Response to Referee 2 Comments on:

Influence of building collapse on pluvial and fluvial flood inundation of metro stations in central Shanghai

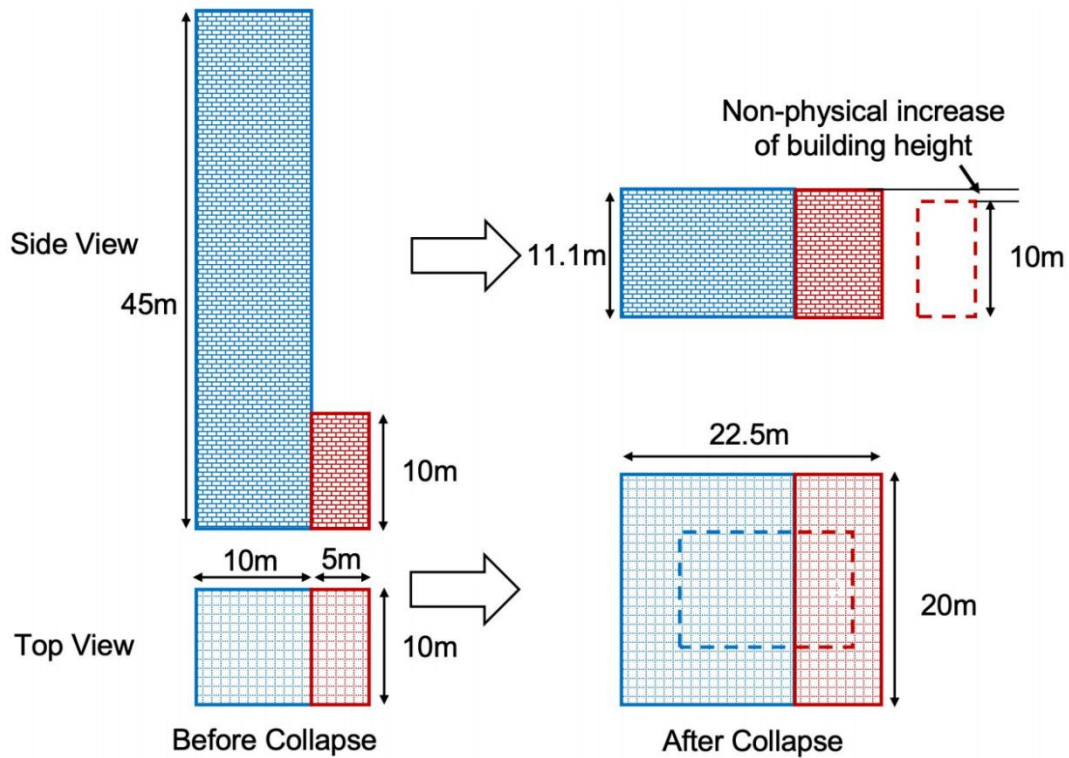
3. 141: The sentence does not become clear, more explanation is required.

chap. 2.3: what happens during collapse is not fully clear; better description or a figure where 1 building is shown before and after collapse, give length, width, height, volume etc.

Response: The third and fourth comments are both related to the description of the building collapse mechanism. We have revised Section 2.3 and added a figure to address the reviewers' concerns :

“building collapse is modeled by distributing certain amount of the “building material” to its surroundings, thereby increasing the spatial occupancy and reducing the height of the building. In this study, we assume that when a building collapses, (i) its spatial occupancy doubles, and (ii) its total volume remains unchanged. The increased spatial occupancy (i.e., the “debris”) is distributed uniformly around the building. The reduced height of the building can be estimated using the volume and the new spatial occupancy. A special case exists when two buildings are adjacent and their spatial occupancy overlap when collapsed. In such situations, the two buildings are treated as one single building when calculating the debris extent. It should be noted that if two buildings with different heights are treated as one building, the final building height after collapse could be greater than its original height, which is unrealistic (Fig.3). However, this phenomenon has negligible influence on the subsequent flood simulation because as long as the building debris is not inundated, slight variation of its height has minor influence on the flow field. That is, the obstruction of the flow path (due to the spreading of the debris extent) has much stronger influence on flood propagation than minor changes of the debris height. With this approach, building collapse is only a simplified representation of the consequence of hypothetical seismic events, but the physical mechanism connecting earthquake and building collapse is not involved.”
